SUBJECT: CERTIFICATION OF THE MINUTES OF THE ACRS EARLY SITE  
PERMITS SUBCOMMITTEE MEETING ON THE VOGTLE EARLY SITE  
PERMIT APPLICATION AND ASSOCIATED NRC SAFETY  
EVALUATION REPORT WITH OPEN ITEMS, OCTOBER 24, 2007,  
ROCKVILLE, MARYLAND

**ADVISORY COMMITTEE ON REACTOR SAFEGUARDS  
EARLY SITE PERMITS SUBCOMMITTEE MEETING MINUTES  
October 24, 2007  
ROCKVILLE, MARYLAND**

#### **High Resolution Compressional Seismic Survey Field Report (Section Appendix 2.5 B)**

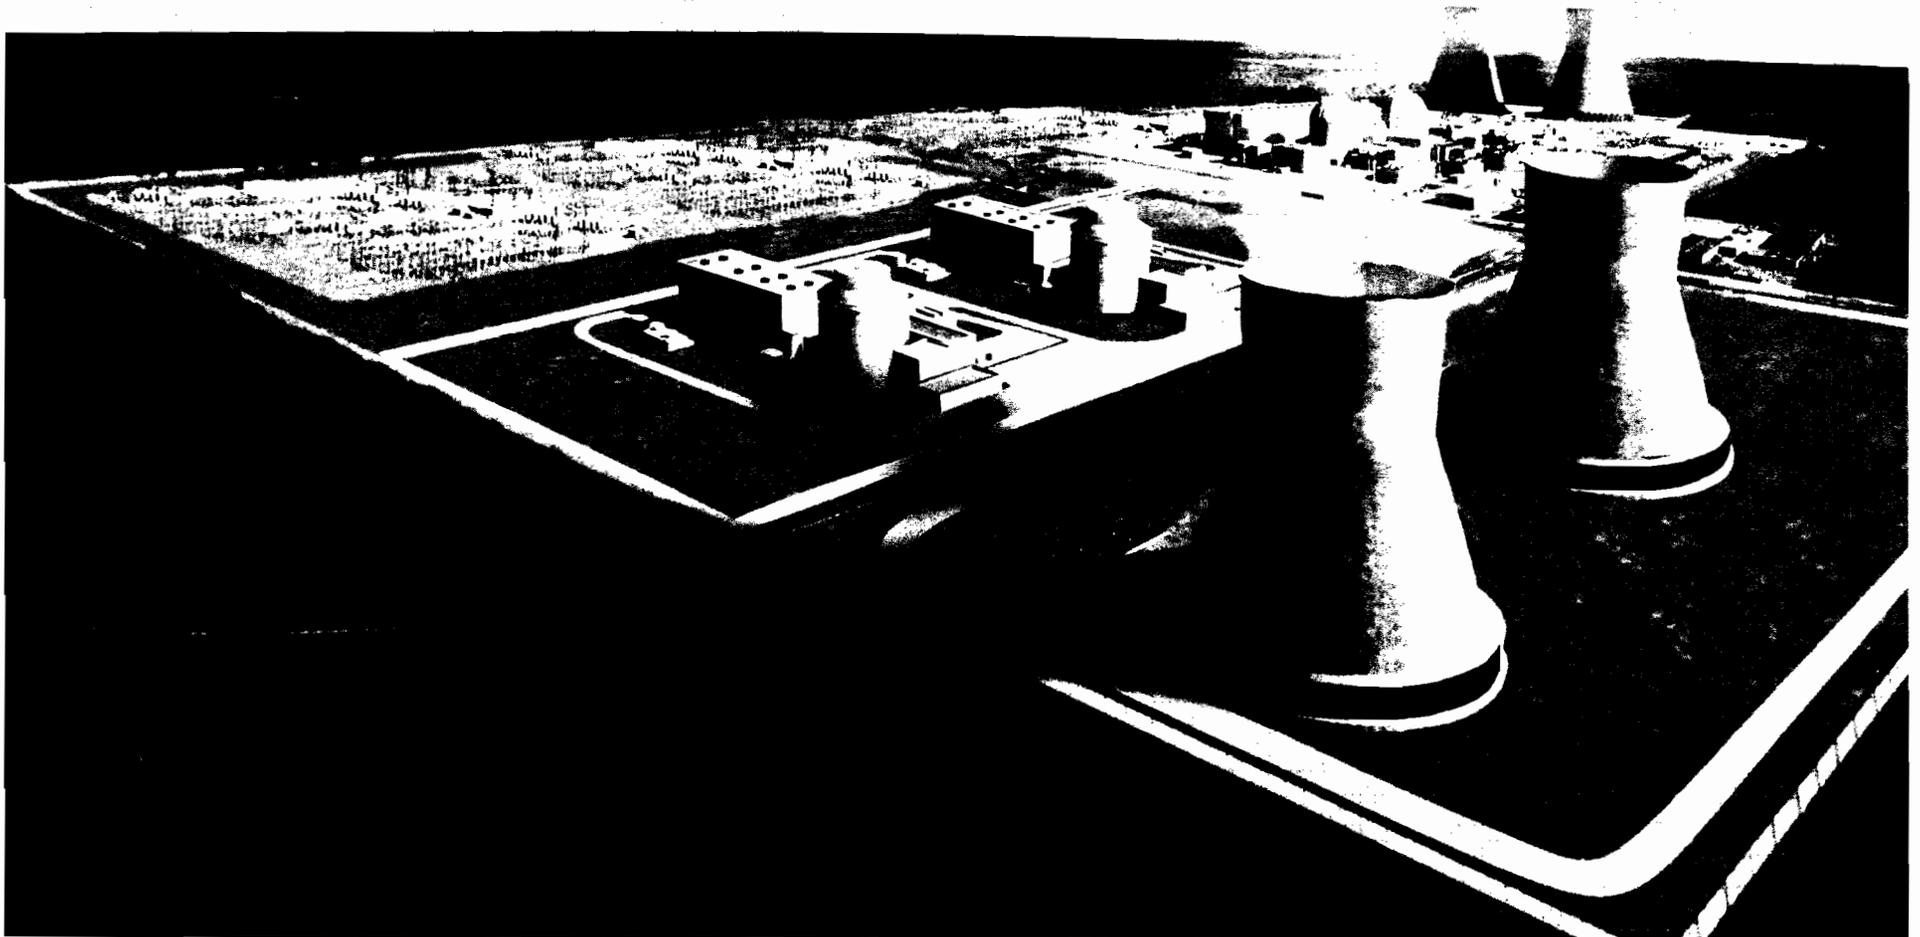
1. There is ambiguity in the interpretation of the results of the reflection seismic survey because the survey is 2-dimensional in nature requiring interpolation of the strike and nature of the Pen Branch fault between the individual survey lines. This is inevitable in a 2-dimensional survey such as conducted at the Vogtle site especially where *en echelon* faults may be present.. This problem could have been minimized by conducting a 3-dimensional survey. The resources needed for acquiring and processing a 3-dimensional survey are considerably greater than for a 2-dimensional survey. However, the importance of achieving the higher resolution in the study of this strategically located fault suggests that the state of the technology methodologies should have been considered for this important study.

2. The seismic reflection survey was limited to the Vogtle site. Consideration should have been given to extending the survey to the southeast where the basement equivalent of the Martin fault may bound the southeastern margin of the Dunbarton Triassic basin. Reactivation of the Pen Branch fault suggests that the Martin fault which is only 30 km from the site may too have been reactivated in more recent time. A seismic reflection study of this fault could have been useful in determining if this fault was active in more recent time. This is important because of the proximity of the southeastern border fault to the Vogtle site.

### ■ **Charleston Paleoliquefaction Features**

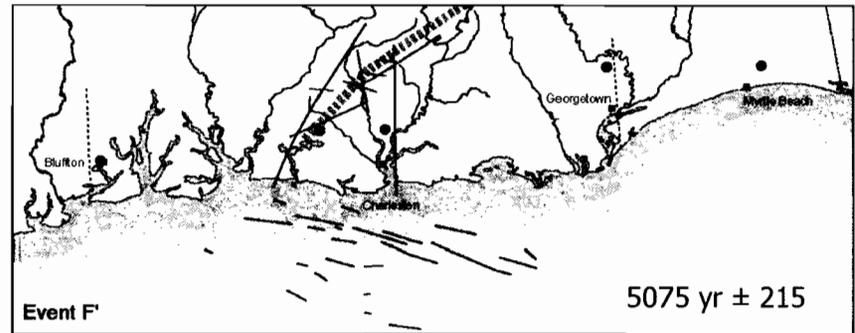
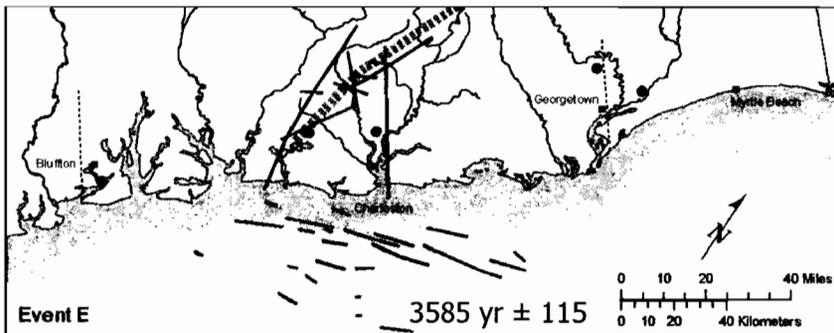
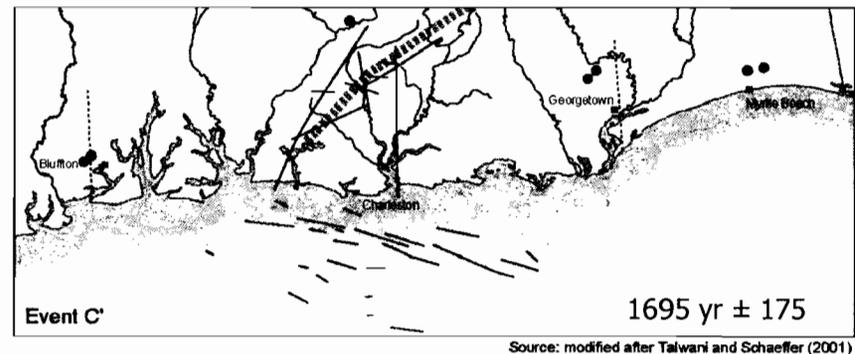
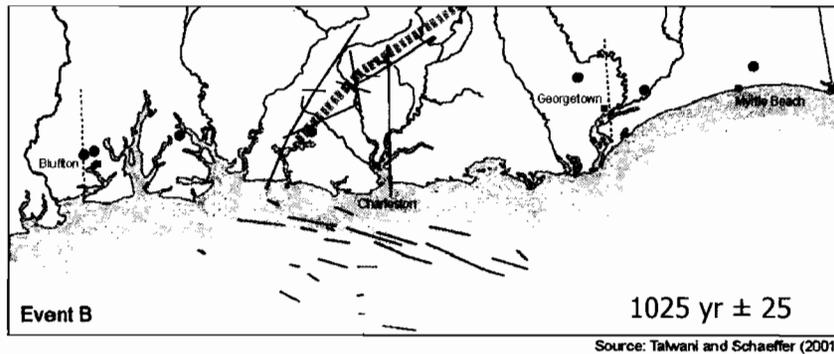
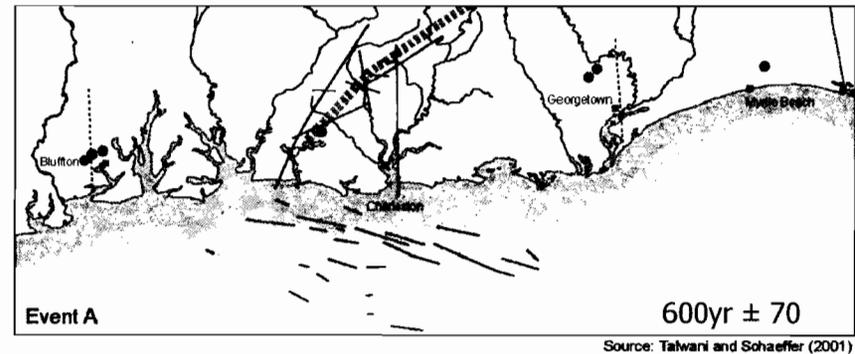
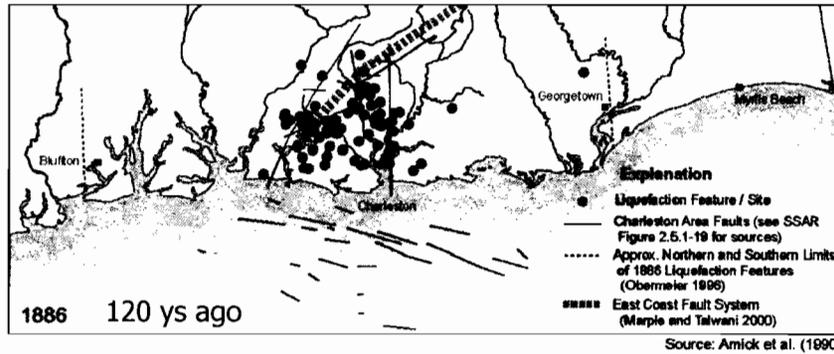
- Paleoliquefaction features, documented since the 1989 EPRI study, contributed to the update of the Charleston source zone

- Liquefaction features represent 5 similar magnitude earthquakes (in addition to 1886) during the past ~5000 years

### ■ **Charleston Paleoliquefaction (Cont'd)** **(OI 2.5-5)**

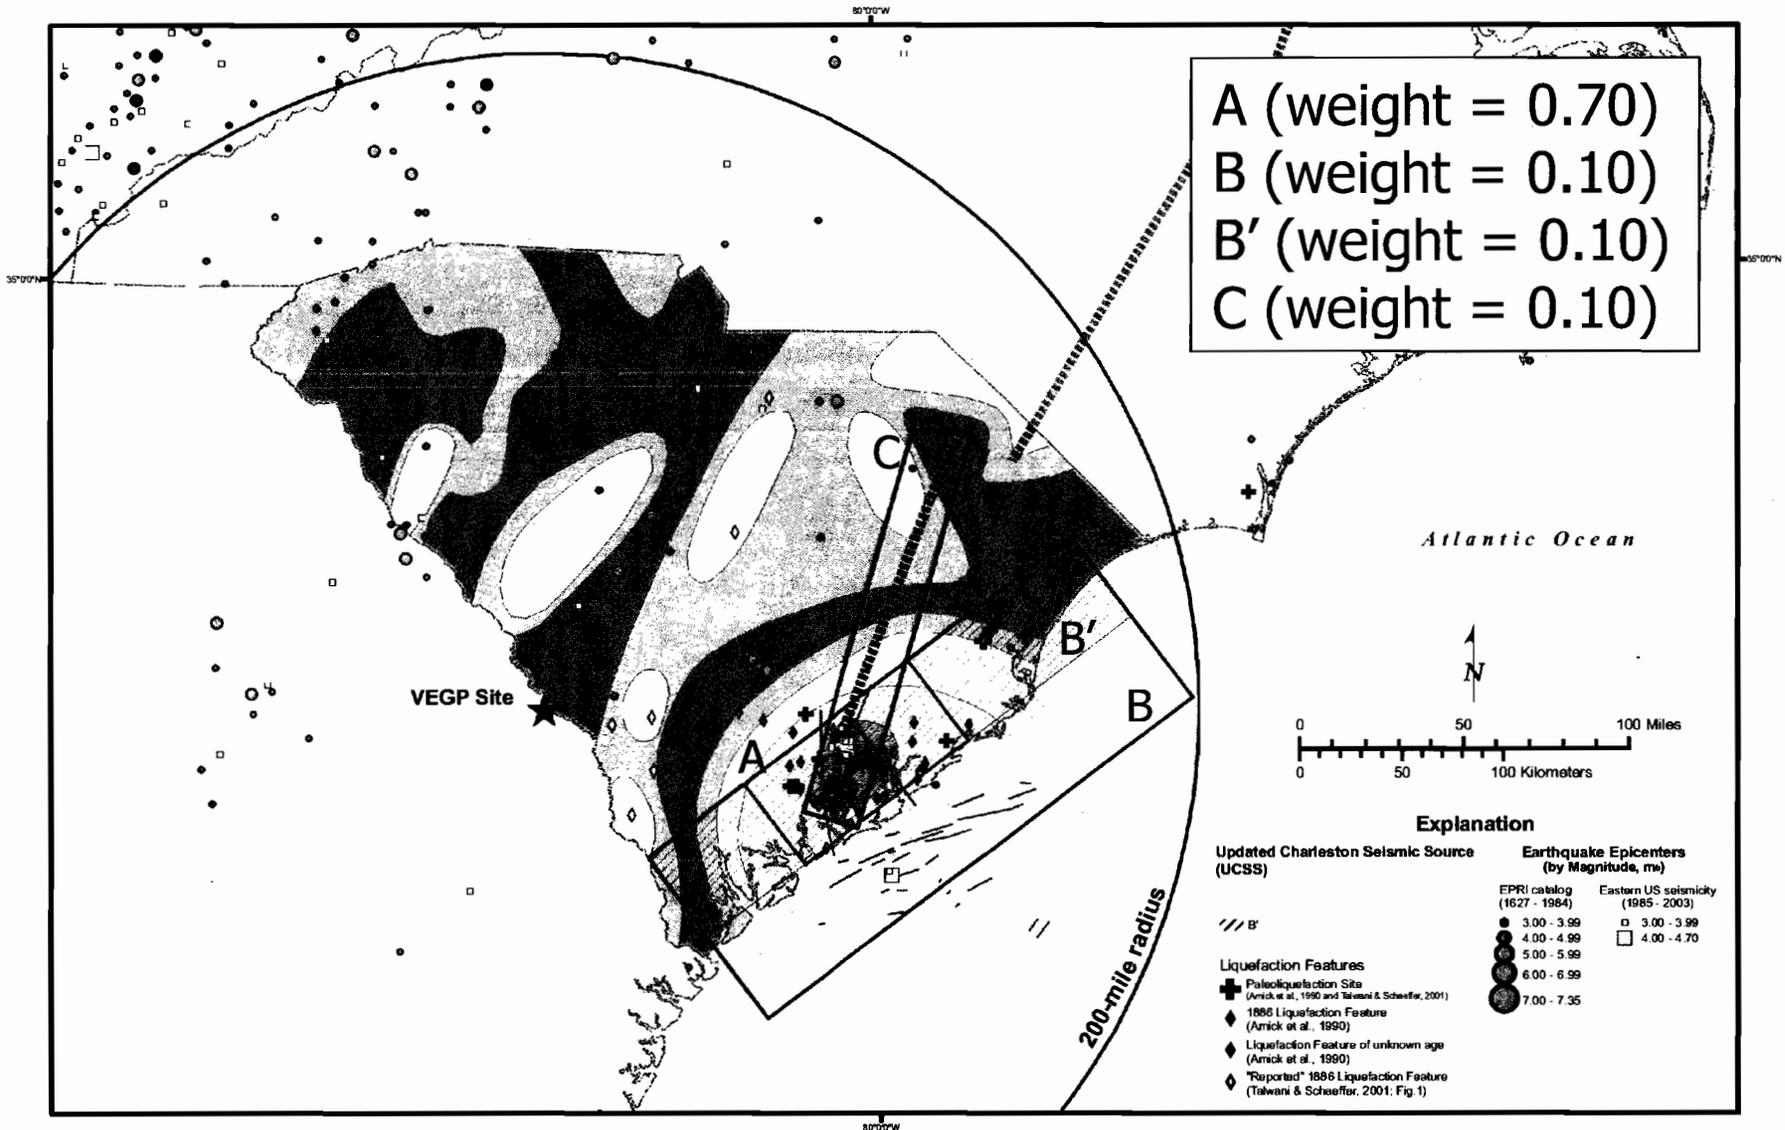
• NRC Staff concluded that the applicant did not provide sufficient paleoliquefaction evidence to rule out the occurrence of large inland earthquakes (OI 2.5-5)

### ■ **Regional Seismic Source Zone $M_{\max}$ and Probability of Activity (OI 2.5-1)**

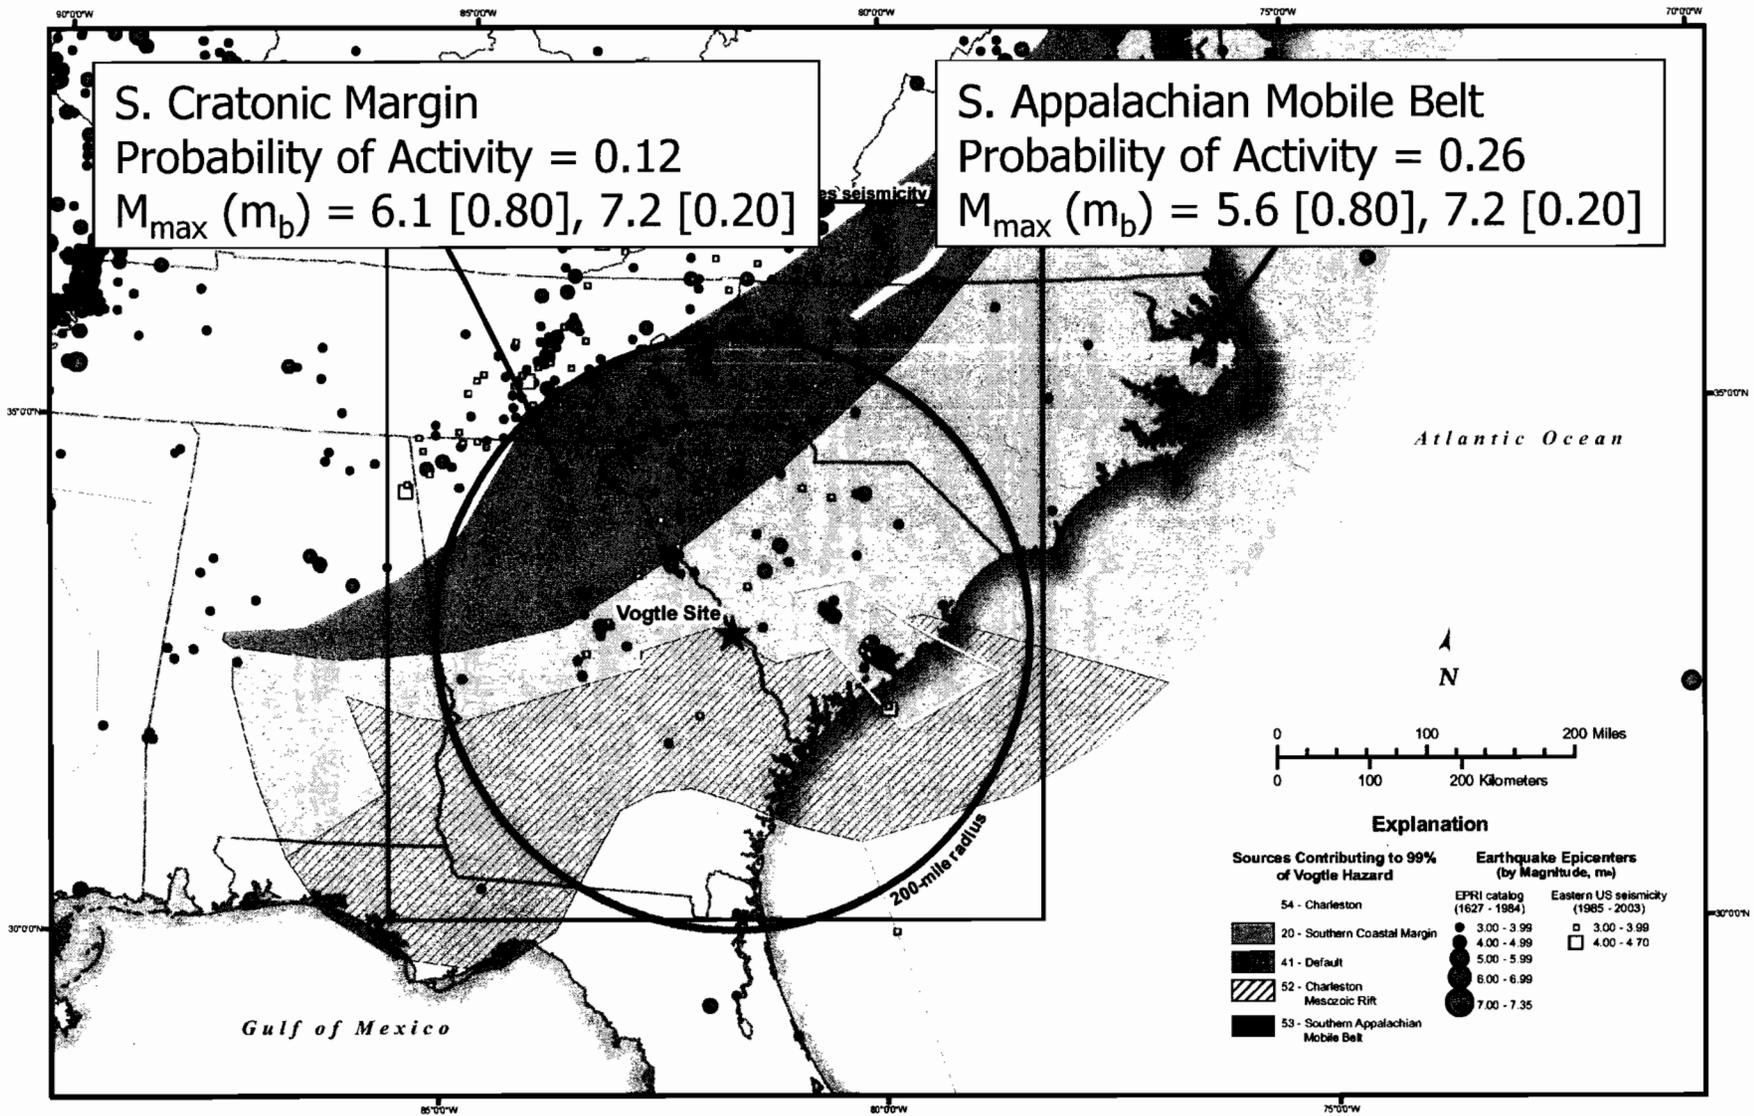
EPRI seismic source zones were determined by six Earth Science Teams during the 1980s
